5 December 2008

Subject: Moruya East Village – Groundwater Issues

Figure 1: Locations of Groundwater Bores

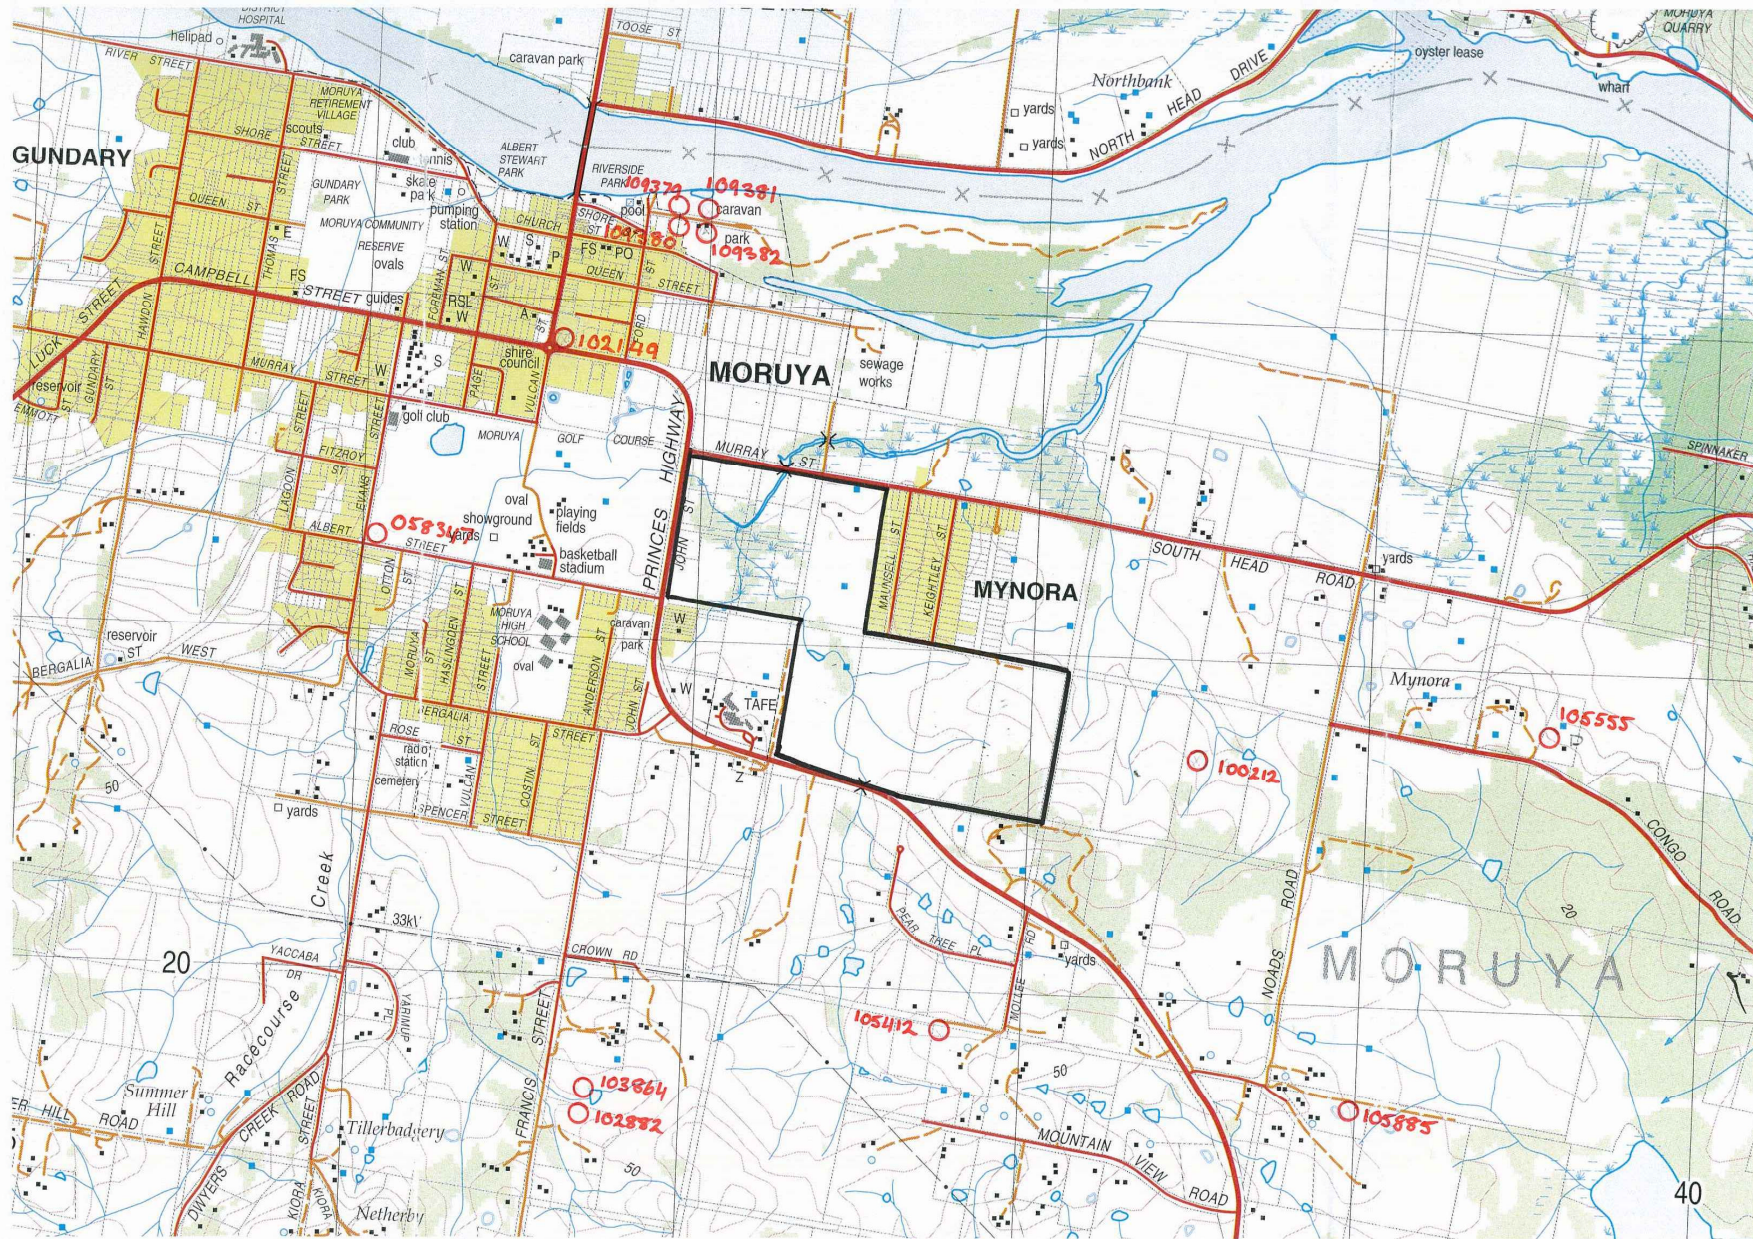
In order to assess the hydrogeology of the locality and the use of groundwater, a search of the DWE groundwater bore database has been undertaken. The location of the identified bores (shown in red) in relation to the site (outlined in black) are shown on Figure 1 attached at the end of this letter. Relevant details of the identified bores are contained in Tables 1 and 2 (also attached at

the end of this letter). None of the bores are located in an area that is influenced by surface runoff or groundwater drainage from the site. Only one bore (105412) is located in the catchment which drains past the development area.

As shown on Figure 1 and the tables, the bores within 1 km of the boundaries of the site come from three different landscape units reflecting their position in the landscape and the underlying geology:

- **Floodplain Zone** – represented by Bores 109379 – 109382 inclusive. These bores, which are located close to the Moruya River, were only drilled to about 3 m deep and encountered silty sand with some shells. Although there is no record of the yield of these bores, it is likely that the groundwater in this locality is in direct connection with the river and to be at an elevation of about 1 m AHD.

- **Lower Slopes** – represented by Bores 102194 and 58347 which are located at elevations between 5 and 10 m AHD. The bore logs indicate that the geology on the lower slopes comprises sandy clay infill deposits overlying decomposed granite with hard granite at depths greater than 15 m. The water table in these areas is at an elevation of about of 2 - 4 m AHD. No yields are recorded for these bores.

- **Mid Slopes** - represented by four bores for which there are bore details (100212, 103864, 105412 and 105555). These bores are located at elevations of 20-30 m AHD and typically encounter a layer of decomposed granite between 5 and 25 m thick. All except bore 105412 (located to the south of the site) have water tables in the range of 6 – 12 m below ground level in decomposed granite. Yields of 0.6 to 1.0 L/s are recorded for these bores. Bore 105412, which is located about 600 m south of the south-western corner of the site was drilled to a total of 92 m but only encountered water within the granite at a depth of 51 m. The very low yield of 0.01 L/s for this bore is indicative of the water being derived from fractures in the granite.

The data from the bores indicates that the groundwater regime on the site is likely to be characterised by:

- Water tables in the range of 2-4 m AHD (approximately the same as the ground surface) in the low lying swampy area (as represented by the groundwater regime on the “Lower Slopes” above).
- Water tables in the range of 6 - 12 m below surface level on the mid slope areas on which the development will be located.
